N4903A-02

S E R V I C E N O T E

N4903A - Serial BERT

Software Update is required after repair due to a component change to the Analyzer Module starting Nov. 1, 2010.

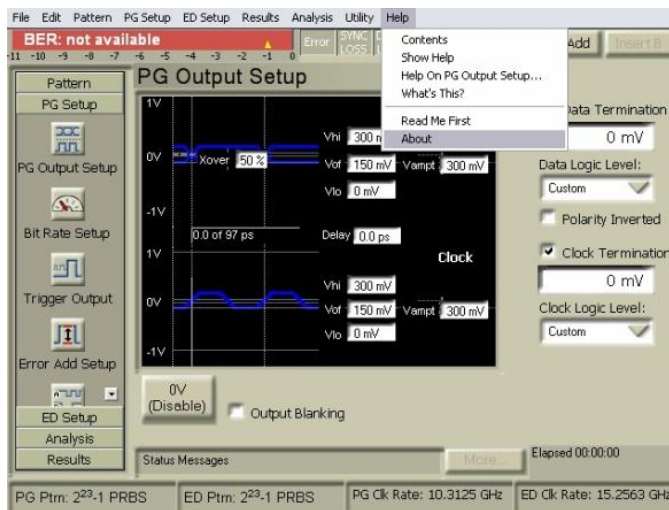
Only the version 4.94 of the software (or later) is “able to deal correctly” with the new component in those parts. If the software is not updated to the latest revision (4.94 or later) the software of the instrument will not start correctly.

You will get **self test errors** as shown in the next picture:

Please keep in mind: please do a software upgrade to 4.94 or later starting Nov 1, 2010 regardless whether you use old or new. From the outside it is not visible whether the spare part contains the new or older component.
